67763 County Permit Review Worksheet Reviewer RR

GWS Septic System Design Review

RE: Request for an Improvement Permit for Lot 38 at The Retreat at Latta Plantation off of Sample Road.
MCHD File #6776B

Design Specifications for Lot 38 off of Sample Rd.
MCHD File # 6776B

Scale: 1 inch equals 50 feet	S&ME	Faison-Sample Road, LLC	FIGURE
Drawn by: JBP		Lot 38	
Reviewed by: Jeremy P. Michelone, RS		Mecklenburg County, NC	1
Date: March, 2007	ENVIRONMENTAL SERVICES · ENGINEERING · TESTING	S&ME Project #1588-05-091

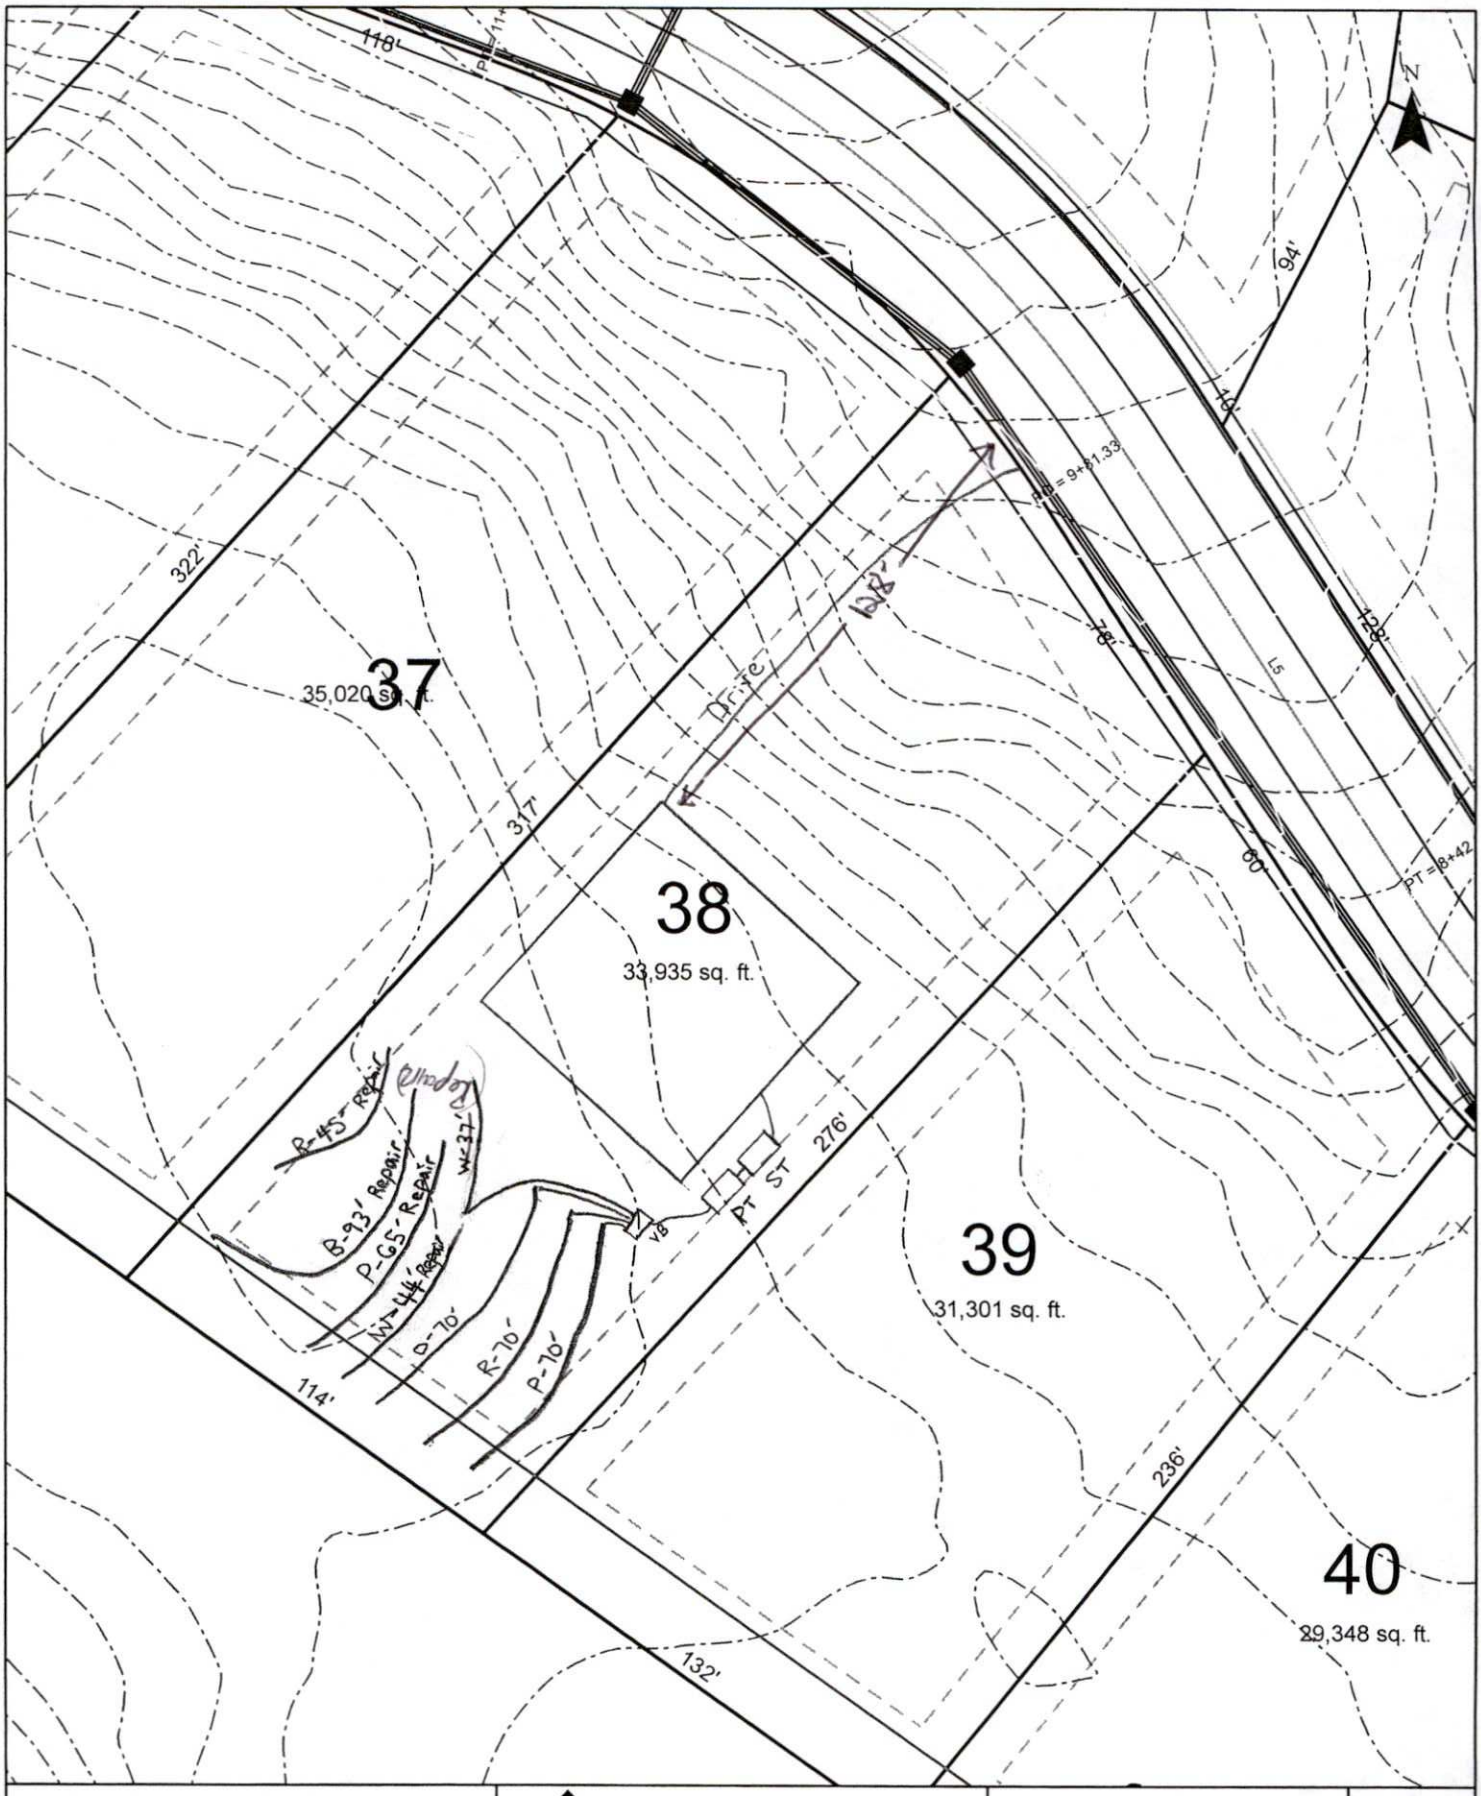
PPBPS Design Worksheet							File #:	6776B
							Tax #:	
System Requirements							Address:	Lot 38 Sample Rd.
Design Flow	480	gpd						
LTAR	0.325	gpd/ft.^2					Consultant:	Jacob Presley - S&ME, Inc.
Linear footage	492	ft. (conventional)					Phone:	336-288-7180
Linear footage	246	ft. (50% Reduction)						
							Reviewed By:	TCT
Design Layout							Date:	4-5-07 ✓
Laterals	Length (ft)	# Panels	Calculated					
Line # 1	70	16	16.15					
Line # 2	70	16	16.15					
Line # 3	70	16	16.15					
Line # 4	37	9	8.54					
Line # 5	0	0	0.00					
Line # 6	0	0	0.00					
Line # 7	0	0	0.00					
Line # 8	0	0	0.00					
Line # 9	0	0	0.00					
Totals	**247**	**57**	57.00					
Absorption Area								
Length (ft)	Width (ft)	Area (ft^2)						
247	3	741						
System Pressure Head	3	ft.	Value selected by system designer (must be between 2-5 ft.)					
Orifice Diameter	5/32	in.	Size selected by system designer (1/8 in. minimum)					
Flow Rate per Orifice	0.5	gpm	Determined from orifice flow design table (use table from Flow Rate tab)

Comments:

1. Install system using 3 ft. wide trenches.
2. Install drainlines on 9 ft. centers, level, and on contour.

3. System design requires effluent pump for distribution.								
4. 100% Repair area is required.

Approved	Disapproved
Design Review: TCT 4-5-07	☒	☐
Field Review: 4/5/07	☒	☐
